**From:** Turchy, Michael A  
**Sent:** Monday, July 7, 2025 10:05 AM  
**To:** Annino, Amy; Jamison, John  
**Cc:** Amschler, Crystal C CIV USARMY CESAW (US); McHenry, David G; Wojski, Paul A; Pjetraj, Michael; Bukowy (HNTB), Kat A  
**Subject:** RE: Request for Additional Information: DWR 20250109 V3 - Hurricane Helene I-40 Pigeon River Gorge Emergency Relief Project

**Subject:** Request for Additional Information: DWR 20250109 V3 - Hurricane Helene I-40 Pigeon River Gorge Emergency Relief Project

# TIP PROJECT: I-40 PIGEON RIVER

**S-006R3: REVISED PERMIT DRAWINGS**  
**DATE: 06/03/2025**

# Erosion and Sedimentation Control Plans

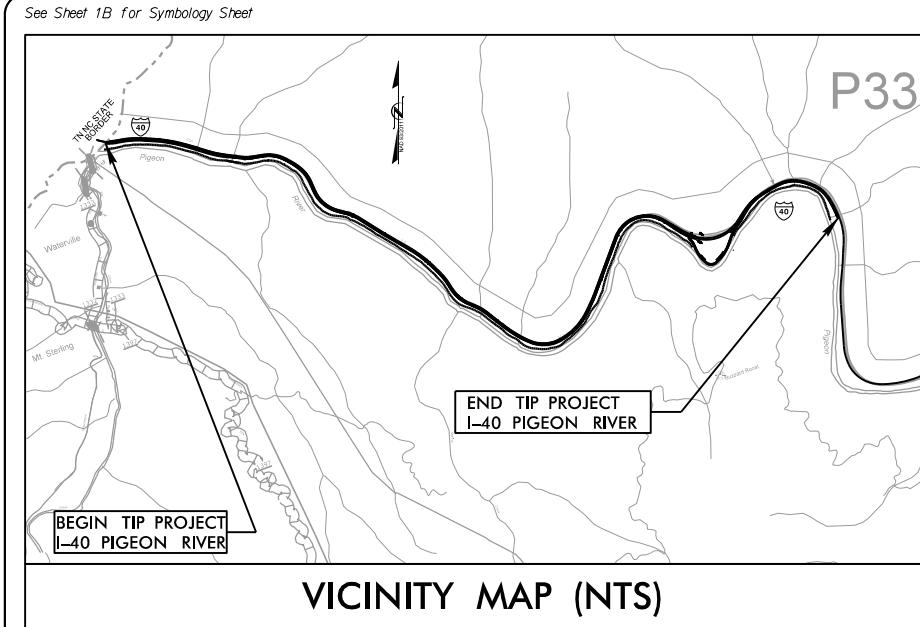
Please provide a plan sheet that indicates the location of proposed stormwater measures for the borrow pit area. [15A NCAC 02H .0506(b)(1) and 15A NCAC 02H .0502(a)(9)].

Please find attached “**Erosion Control at Borrow Site**”.

**CALCULATIONS:**  
 - RISER BASIN  
 $Q = Q_{10\text{peak}} \cdot C_{IA} = 0.2 \cdot 3.97 \text{ in/hr} \cdot 39.1 \text{ ac} = 31.1 \text{ cfs}$

Adisturb = 25.8 ac  
 AREA REQUIRED =  $A = 435 \cdot Q = 435 \cdot 31.1 = 13,529 \text{ ft}^2$   
 AREA PROVIDED = 13,530  $\text{ft}^2$

VOLUME REQUIRED =  $V = 1,800 \cdot \text{Adisturb}$

= 1,800 \* 25.8 ac = 46,440  $\text{ft}^3$

VOLUME PROVIDED = 68,490  $\text{ft}^3$

# Permit Drawings with Wall Highlighted

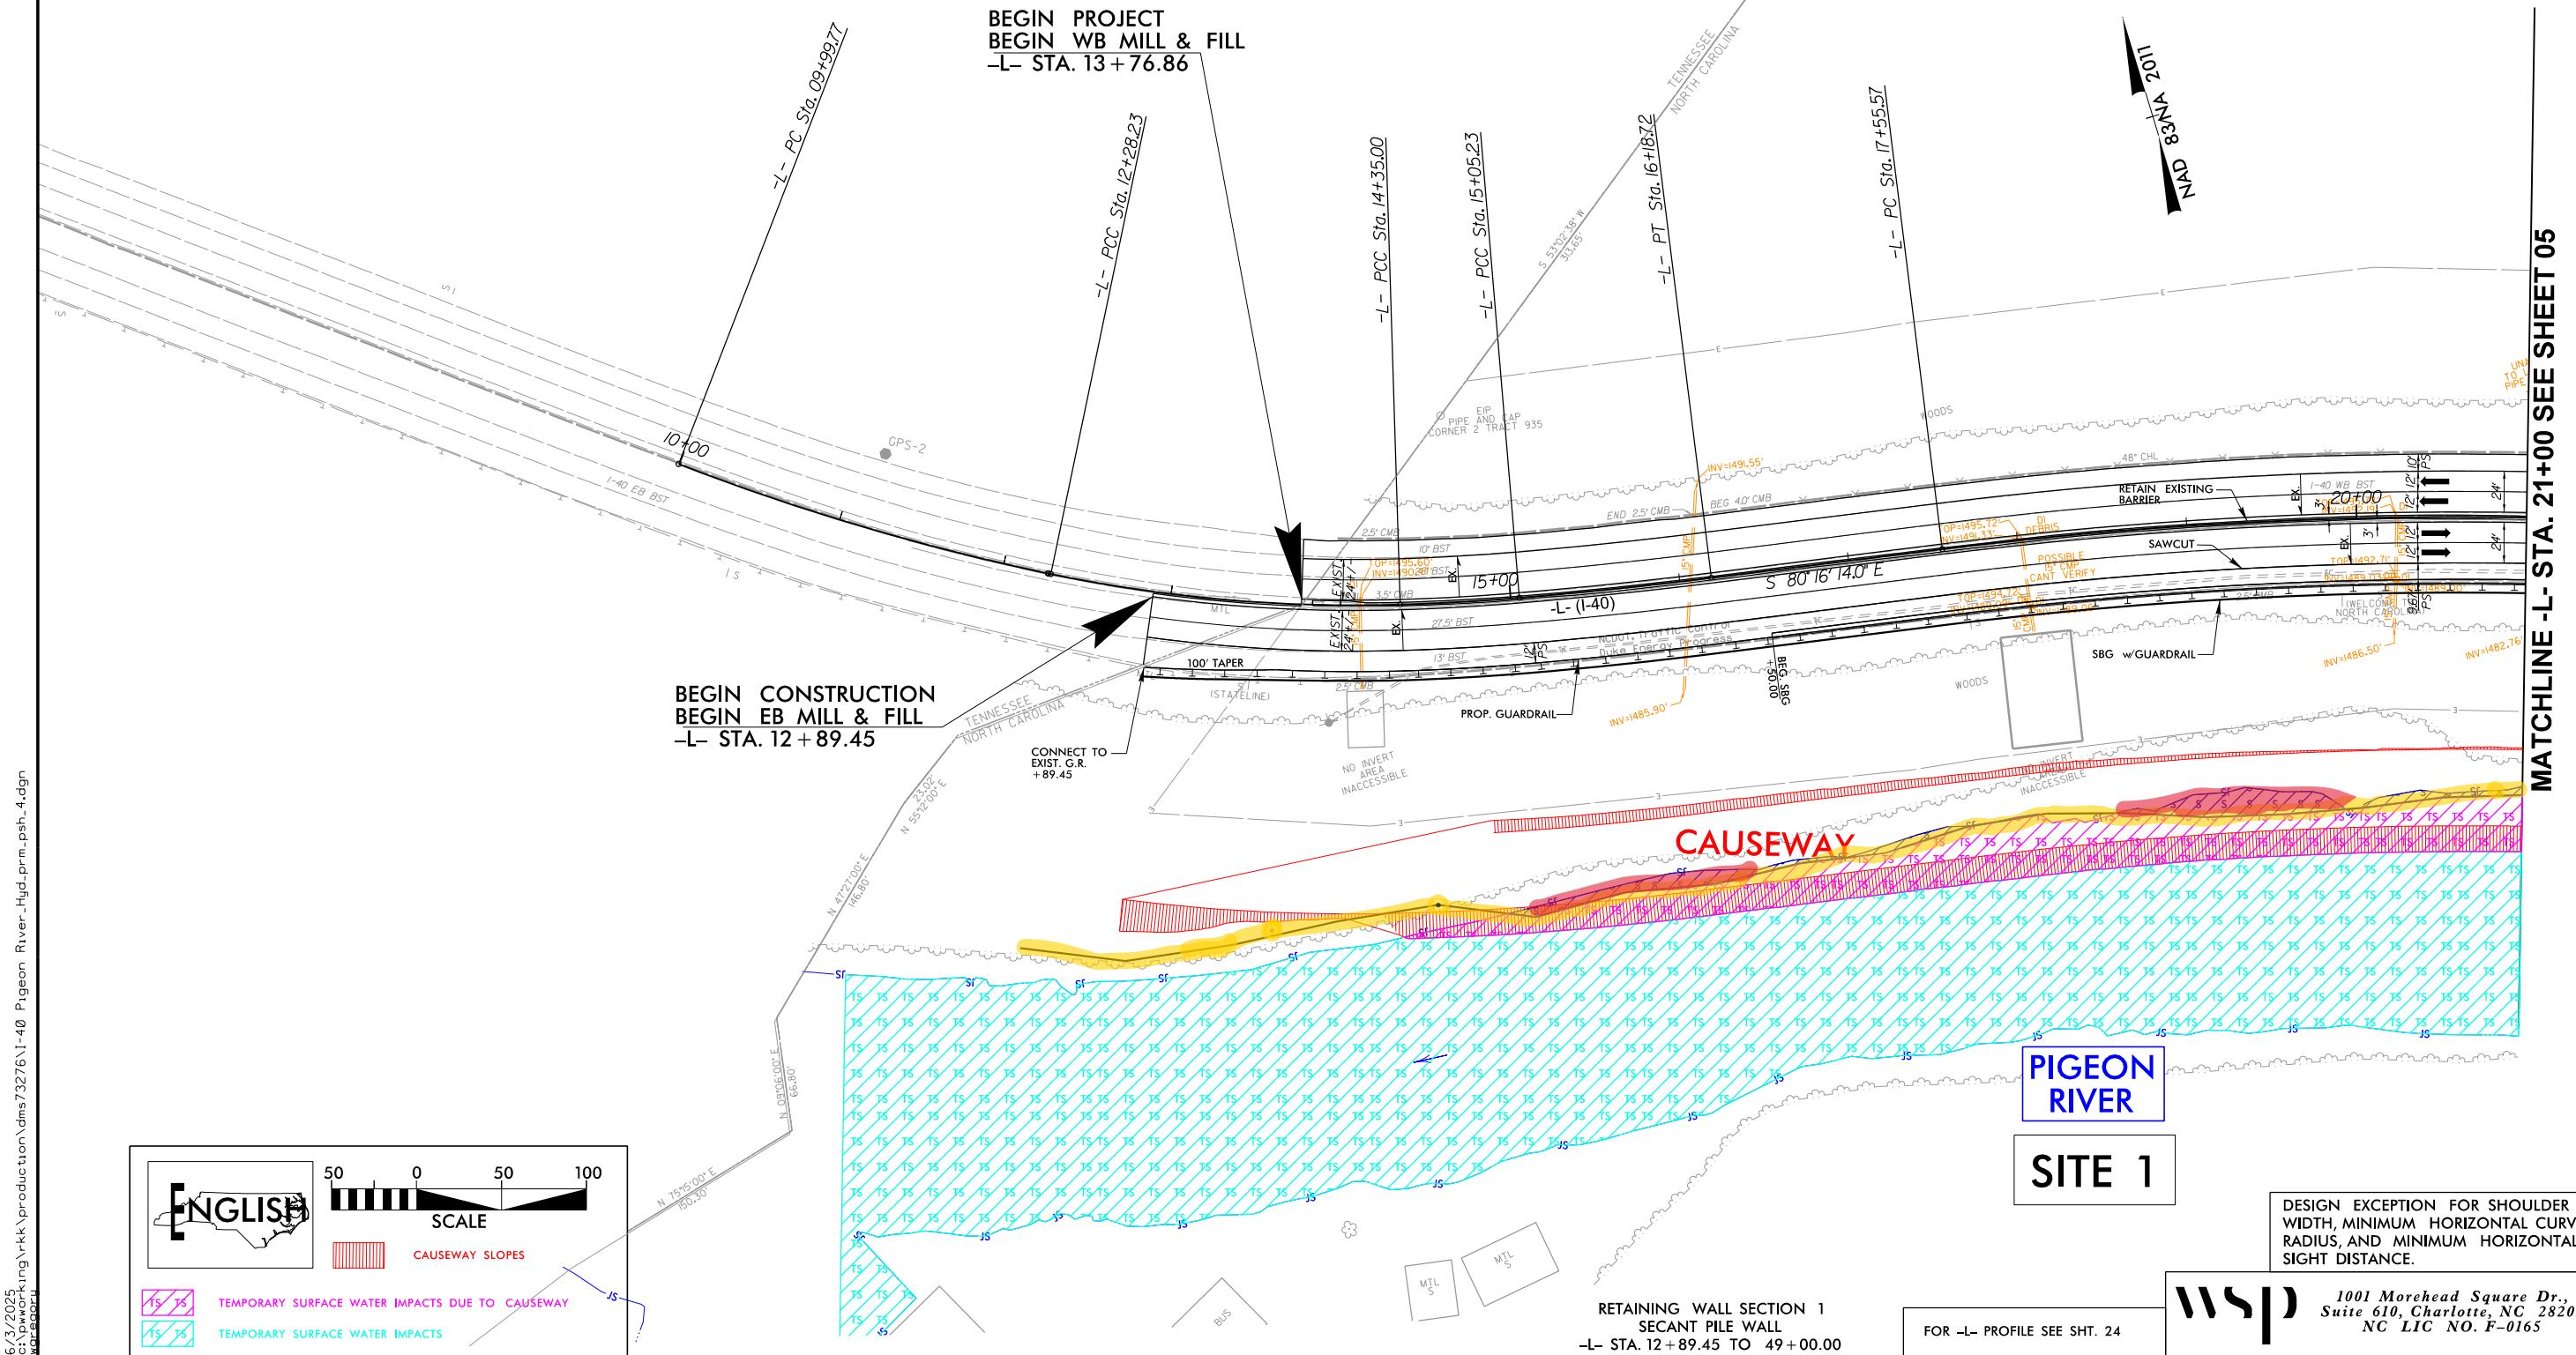
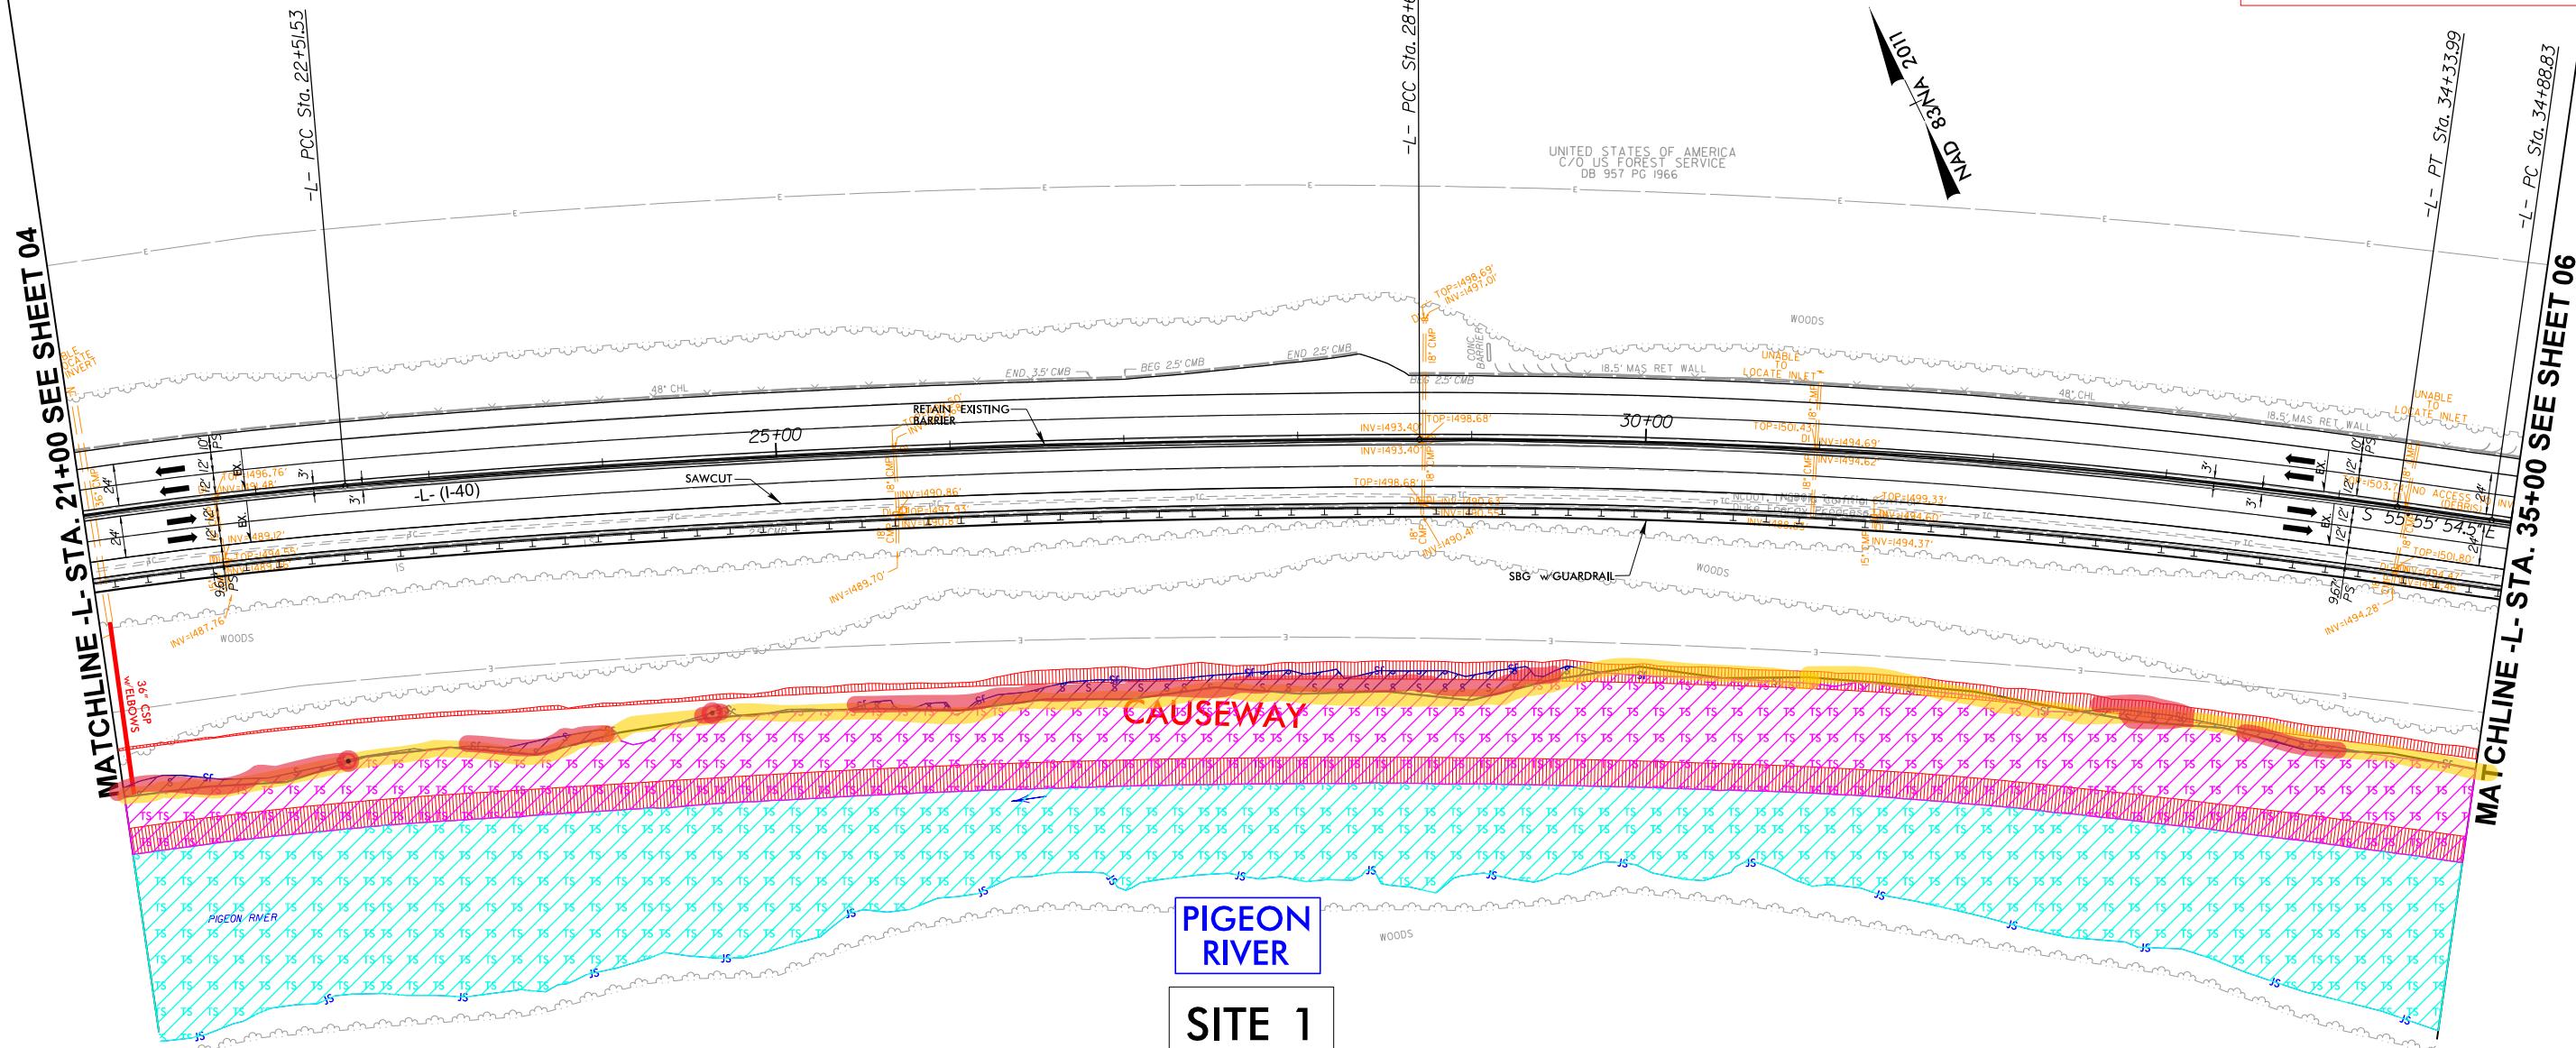
3. Please show the footprint of the proposed retaining wall through the project area

The proposed wall is located on the submitted set of drawings, and attached is a marked up set of drawings highlighting the wall for clarity, titled “**Drawings with Wall Highlighted**.”

The wall is highlighted in yellow. Wall impacts are highlighted in red.

Additionally, the impact summary table has been excerpted on each page to clarify the quantify the wall impact.

As previously noted, impacts are shown using the “scour zone limits” of the Pigeon River, as locating the ordinary high water mark post-Helene is not possible. Therefore, these drawings display a “worst case scenario” and are likely much lower than indicated.

The total proposed wall impacts to the Pigeon River are 12,116 linear feet.
